DOMINION NUCLEAR CONNECTICUT, INC.
MILLSTONE POWER STATION UNIT 2
RESPONSE TO REQUEST FOR ADDITIONAL INFORMATION
REGARDING INSTRUMENTATION TECHNICAL SPECIFICATION CHANGES

INSTRUMENTATION TECHNICAL SPECIFICATION CHANGES
RESPONSE TO REQUEST FOR ADDITIONAL INFORMATION

CALCULATION ZPM DRIFT-0426012, REV 1, DATED 11/7/07
ZERO POWER MODE DRIFT ANALYSIS IN SUPPORT OF LBDCR 06-MP2-036

Figure 4: Upper Trip Setpoint Derivation

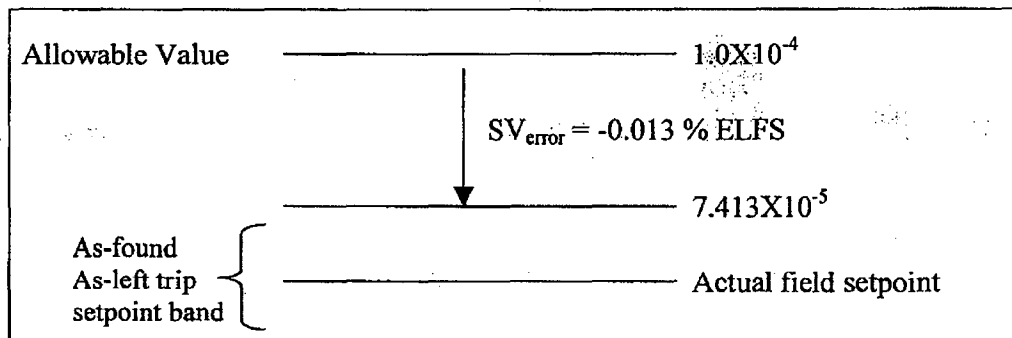
7	13/6.8	Define SV.	Added
8	14/6.8	Add AV after Allowable Value. MAX FACTOR = 1.349^{+1} ; MIN FACTOR = $1.349^{-1} = 0.7413$. Use parenthesis in lieu of asterisks.	Incorporated
